**From:** Olson, Greg R.  
**Sent:** Tuesday, December 18, 2012 11:23 AM  
**To:** 'Jeff Wooten'  
**Cc:** Olson, Greg R.  
**Subject:** D12-D006 Sagebrush Plaza (Tract 1-D-1-A, Bk 15, Alban Hills Unit 1)

**RE: SAGEBRUSH PLAZA, TRACT 1-D-1-A, BLK 15, ALBAN HILLS-GRADING AND DRAINAGE PLAN NE CORNER OF COORS & LA ORILLA NW  
P.E. STAMP 11/5/12 FILE# D12-D006**

RE: **Sagebrush Plaza, Tract 1-D-1-A**, Blk 15, Alban Hills - Grading and Drainage Plan  
NE Corner of Coors & La Orilla NW P.E. Stamp: 11/5/12 File # **D12-D006**

**RE: SAGEBRUSH PLAZA, GRADING AND DRAINAGE PLAN  
ENGINEER'S STAMP DATE 10/2/2012 (D12/D006)**

| Proposed Sagebrush Plaza Drainage Calculations           |         |                  |                            |        |       |        |        |       |                       |                        |
|----------------------------------------------------------|---------|------------------|----------------------------|--------|-------|--------|--------|-------|-----------------------|------------------------|
| <p><b>RONALD R. BOHANNAN</b><br/>P.E. #7688</p>                                                                         | <p><b>GRADING AND<br/>DRAINAGE PLAN</b></p>                                                                                            | <p><b>DATE</b><br/>11/01/12</p>     |

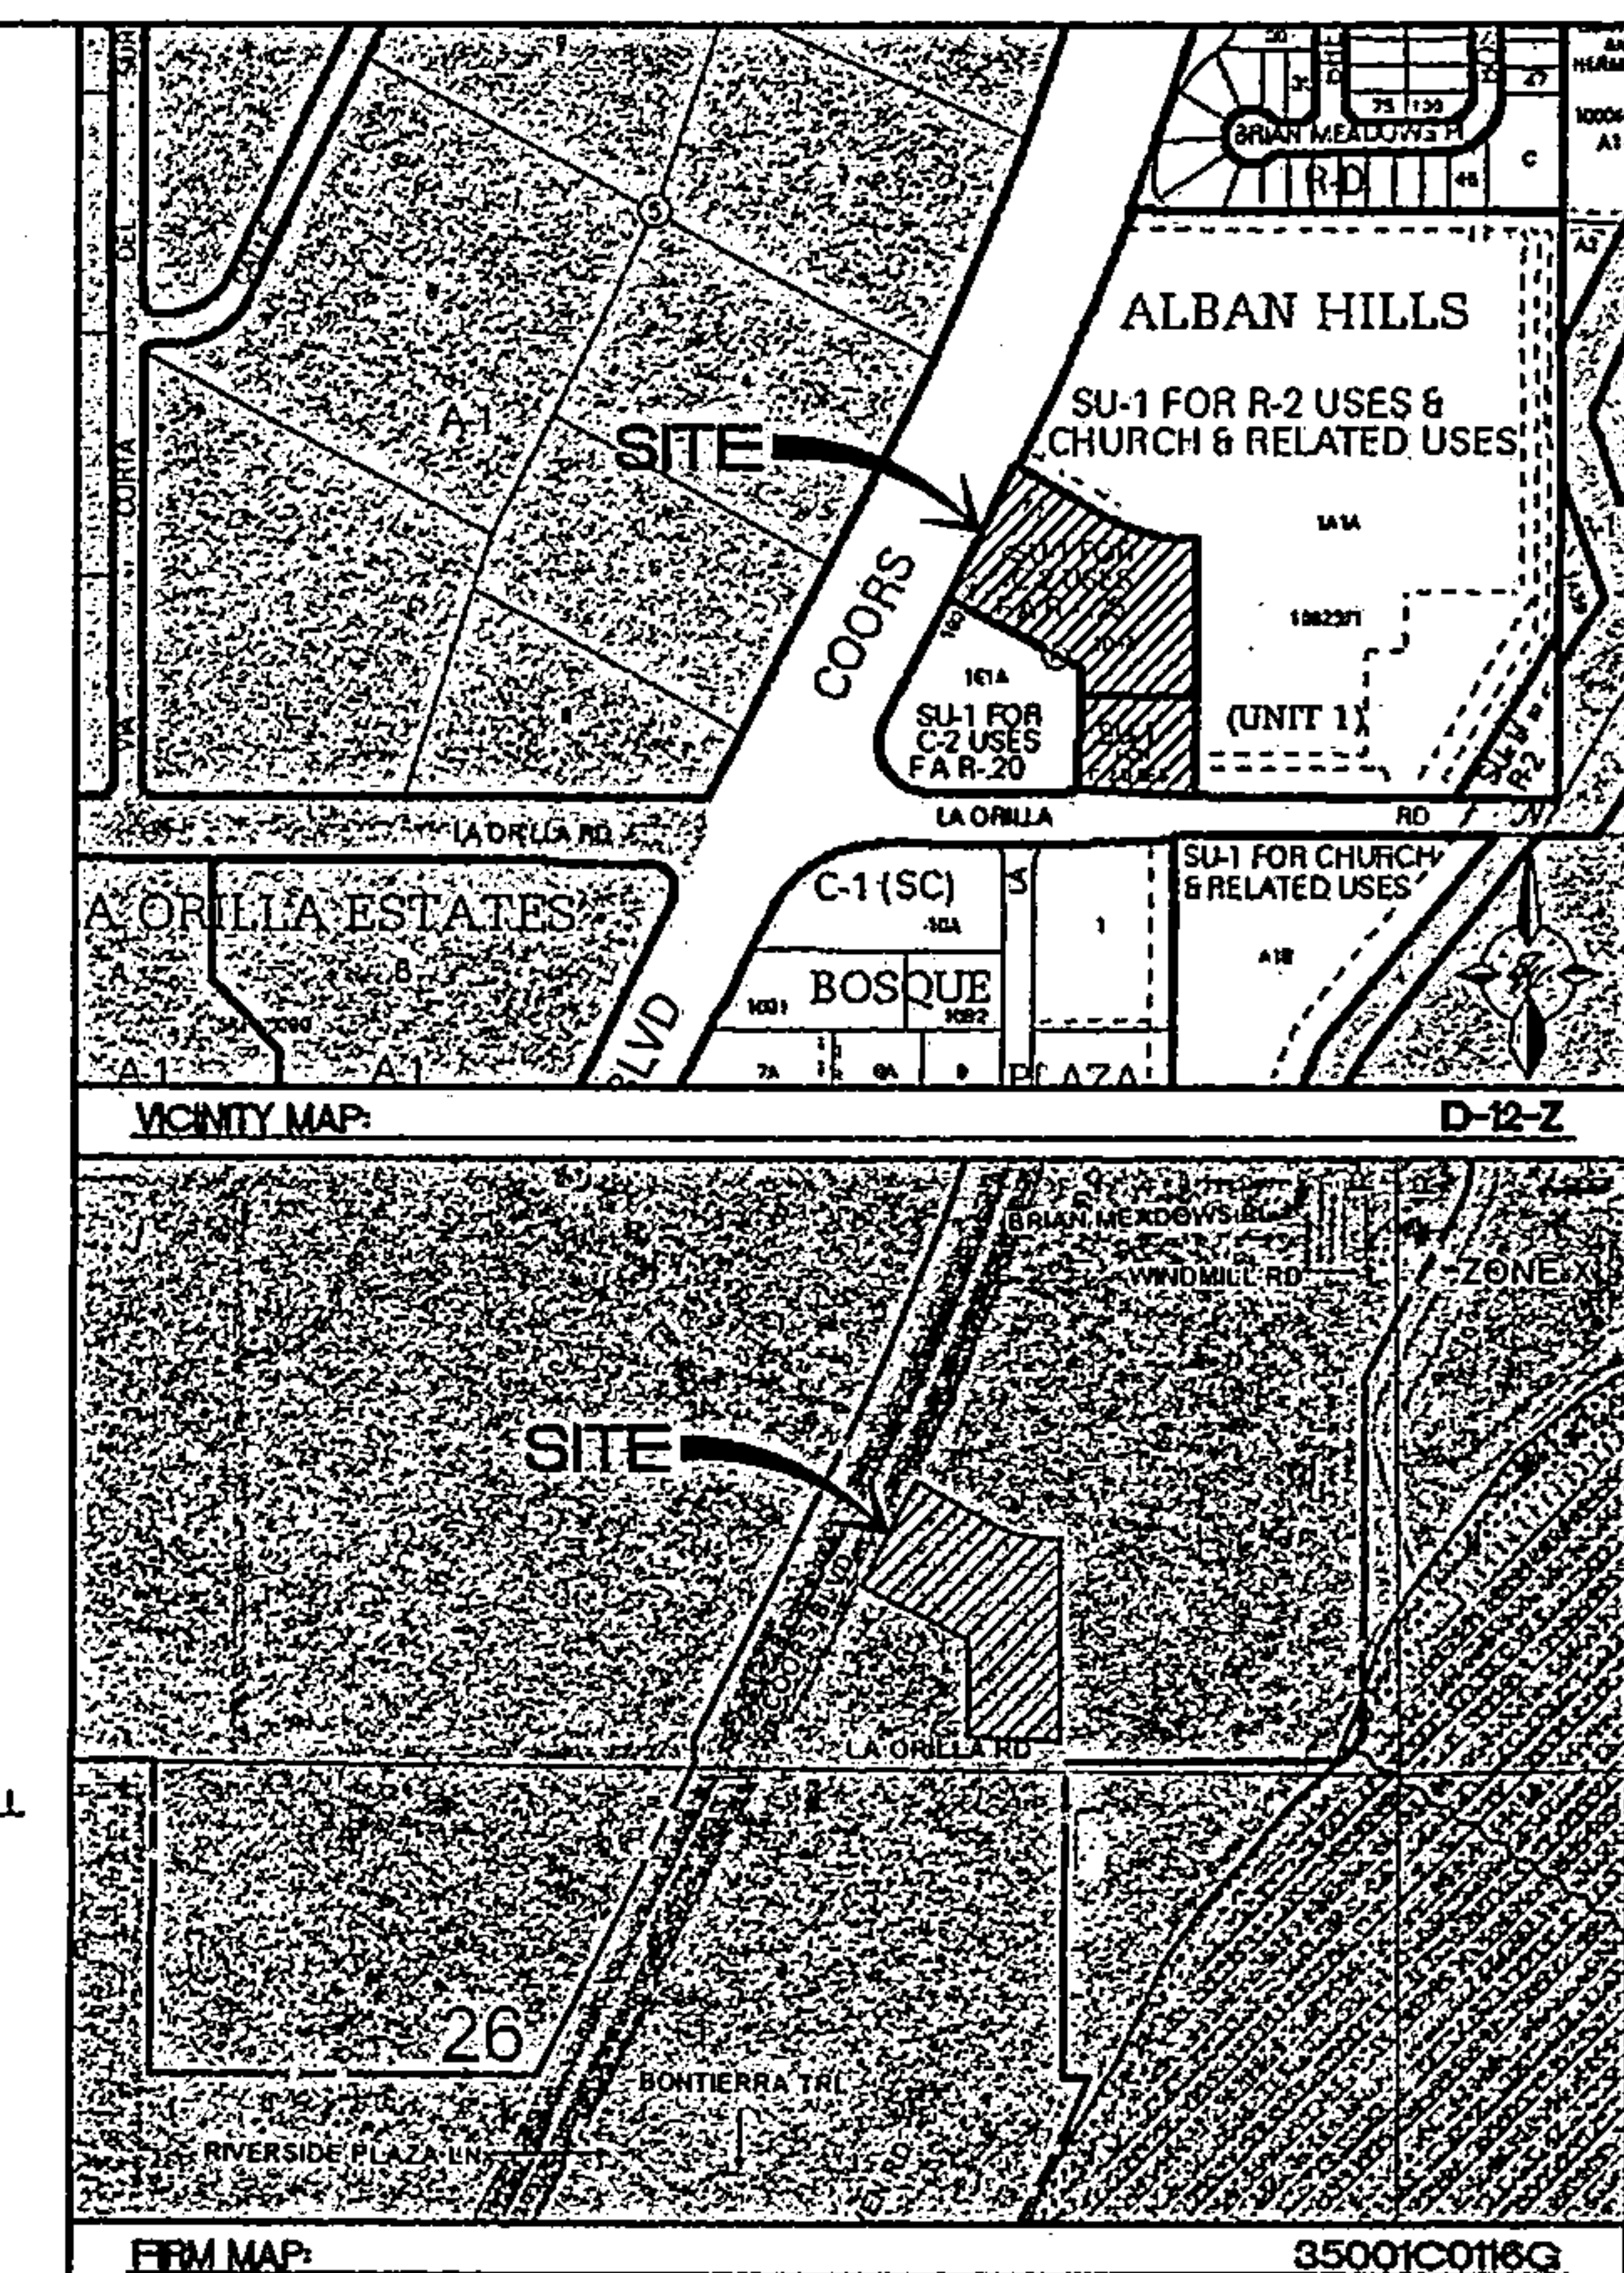
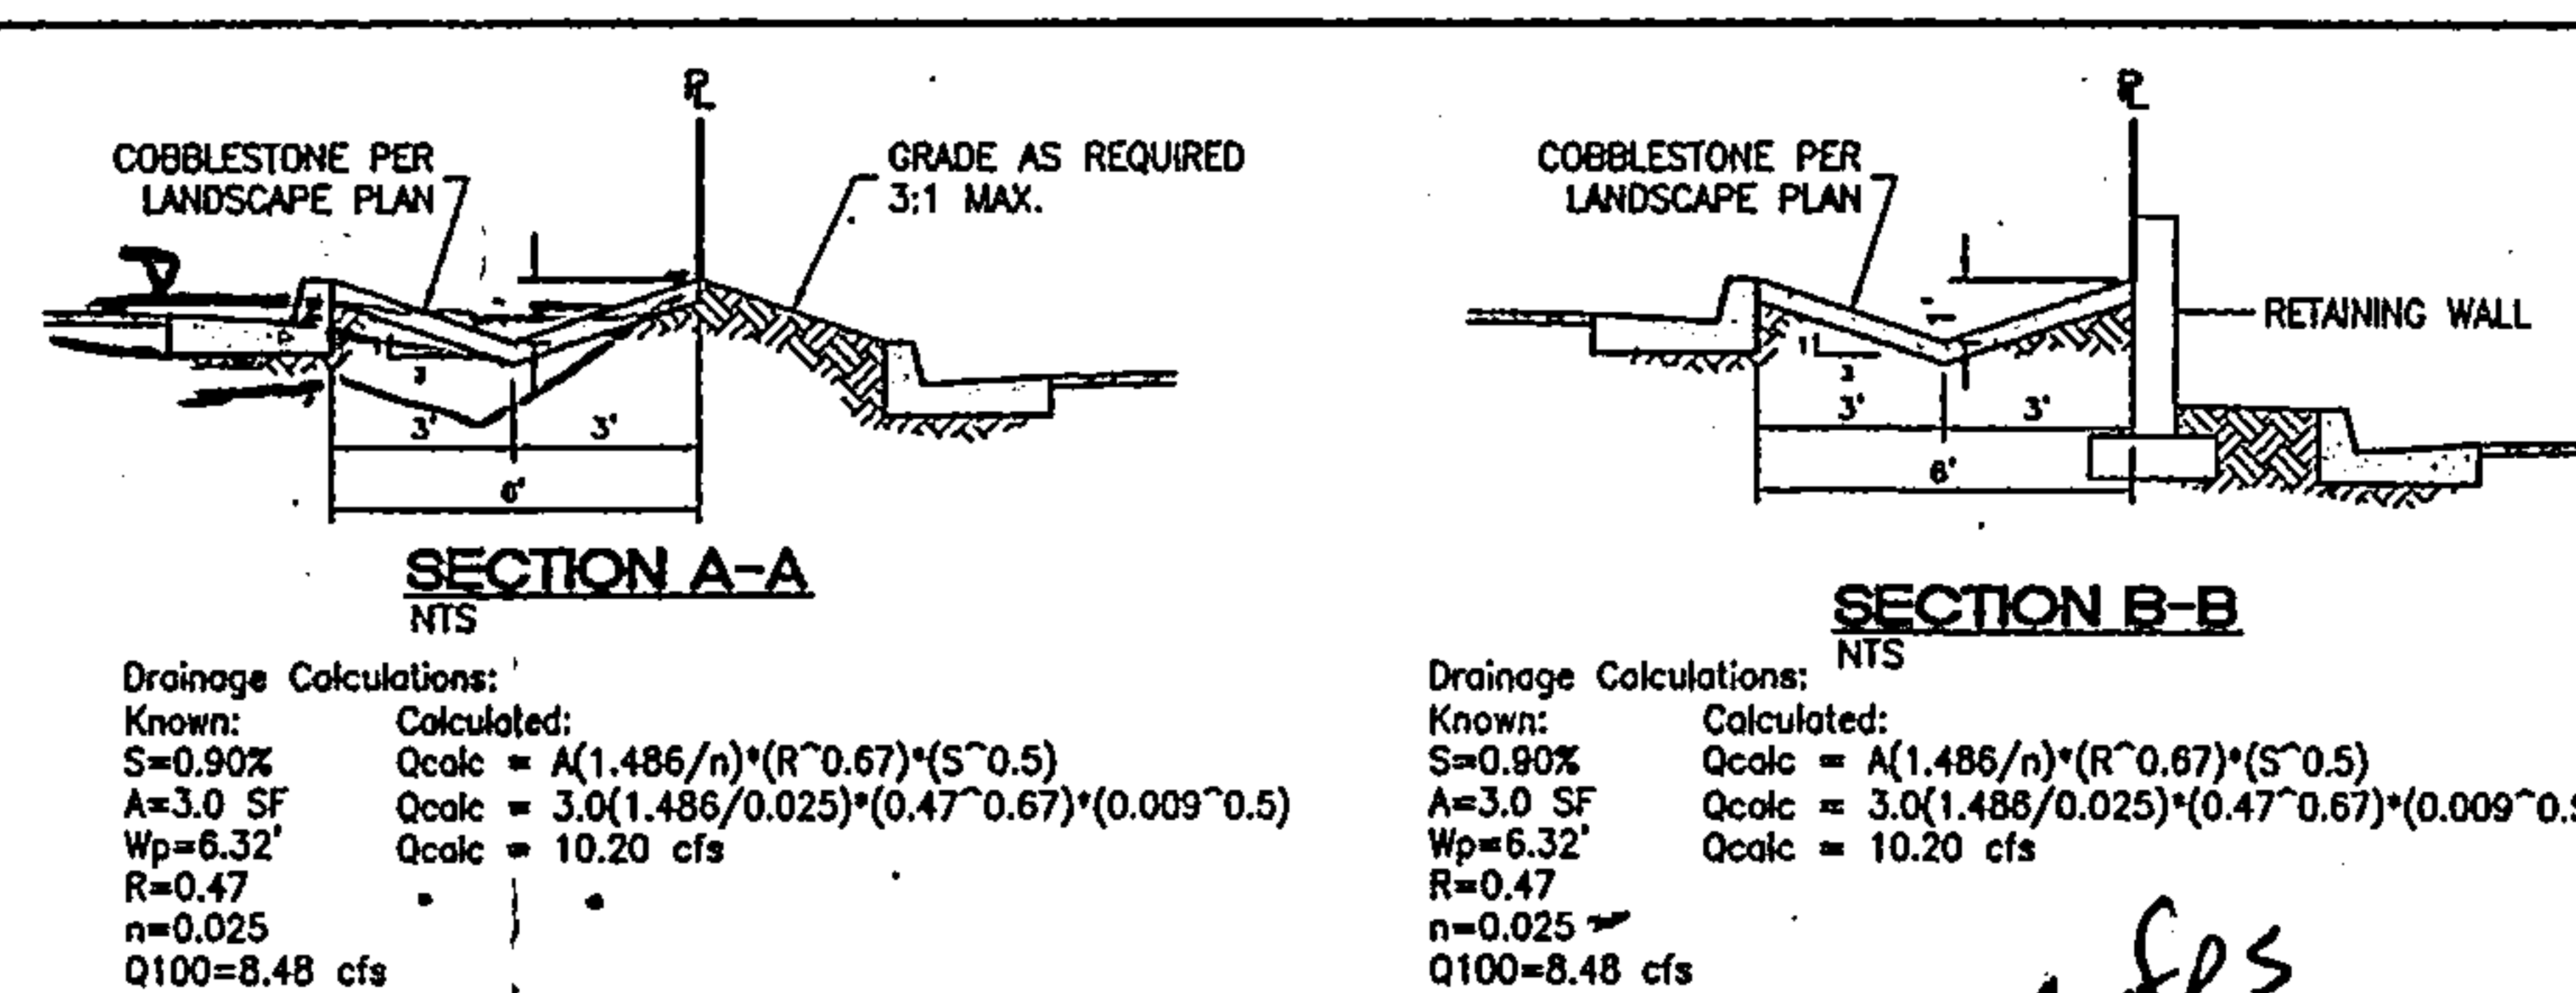
1. Calcs were not provided for the 8.48 cfs Q in the east swale, however this appears to be the sub-basin discharge for the northern portion of Basin 1.

2. The Grading Plan does not call out a curb cut from the 3-space parking bay, south of the water harvesting area between the building pads.

There appears to be one shown in the plan, but it must at least be constructed, and included on your Certification plan.

3. This plan reduced the water block on the church lot from 6" to only 4" at one point. Review of your calculations noted:

a. The n-factor for pavement should be 0.017, per the DPM, rather than the 0.015 used.

b. The slope of the existing valley gutter is as low as 0.67%, based upon the new grades provided, rather than the 1% shown in the calc table.

c. The 4" water block only appears to occur at the east side of the southern median nose. The rest of the grades provide a block of 0.4' to 0.5'.

Can the corrected flow be contained within the property by raising that 4" grade(s) ?

1. You are correct about the sub-basin. I verified the calculations and the 8.48 cfs is correct.
2. I have added the label for the 24" curb opening in the area south of the water harvesting area. The curb opening has already been installed. We will verify this on the drainage certification after the buildings are constructed with Phase 2 and a drainage certification is required.

C7

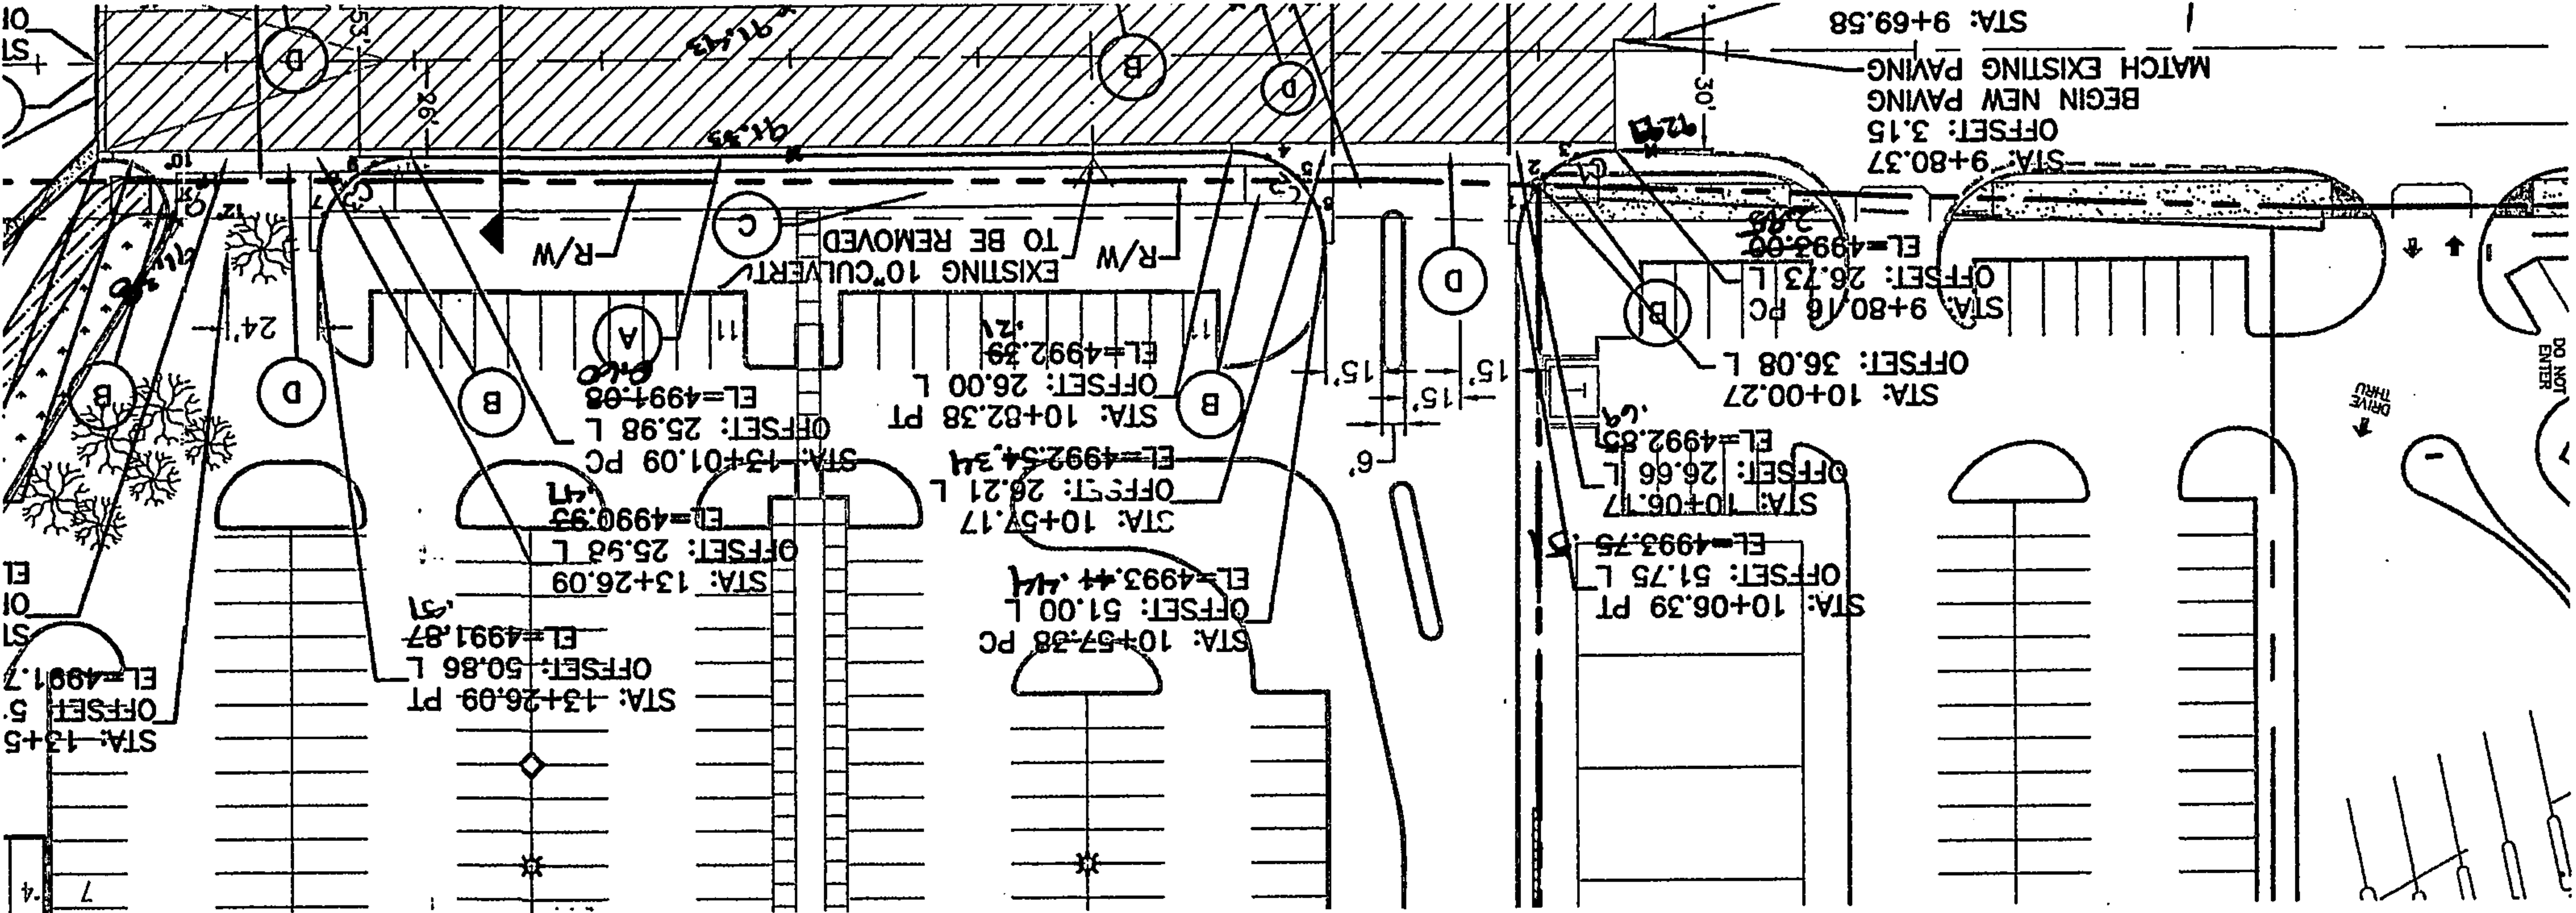
2. **East Side Channel appears to be too small.** Calculation included used a Manning's n-factor of 0.025 for a cobble surface. DPM and FHWA references suggest that this value should be higher; between 0.035 and 0.050. However, the Site Plan submitted 12/4/12 included a landscaping plan with "Gravel Mulch" ground cover in the channel. It also includes plantings, which will inhibit flow in the channel. The design concept seems fixable, by adjusting calculations to reflect actual landscaping surfaces, and recognizing additional capacity in the pavement west of the channel, via the proposed curb openings. My only remaining concern is at the southern 85' of the channel (Section A-A), where there is no freeboard to inhibit overflow and erosion on the adjacent lot to the east.

3. **Clearly show the limits of the existing, retaining wall** (Section B-B) adjacent to the channel. Section A-A is beyond the south end of the existing retaining wall, and proposes grading on the adjacent property. Is this grading approved by the owners of that property?

4. **Missing flow line elevations in La Orilla Rd** at the drive entrance are requested to aid in confirmation of an adequate water block on the church site to the east. Provide the grades on La Orilla, and some additional spot elevations along the flow-line of the pavement/swale, upstream of where flow crosses easterly to the church site.

**Response: We have reviewed the DPM and do not find a direct reference to cobble for the Manning's n-coefficient. However, we have reviewed the FHWA Guide to Selecting Manning's Roughness Coefficient. According to this document, the Manning's n-coefficient for cobble between 64mm and 256 mm (2.5" to 10") in size should be between 0.30 and 0.050. Since our cobble is on the low end (less than 4"), we have chosen to use the 0.030 value. We have also modified the swale sections such that the west side of the swale matches the FL of the adjacent curb which gave us the additional cross section area we needed. Please review the revised plan and let me know if this alleviates your concern. Upon inspection during the drainage certification, we will ensure the eastern side of the berm is higher than the curb to the west to prevent any breaches in the swale.**

**Response: The limits of the existing wall were labeled. The developer of this property and the neighbor to the east are the same. They are aware of the grading that will occur off-site and have sent an email to Curtis Cherne that they are ok with this work.** ? ✓

**Response: Additional grades were added.**
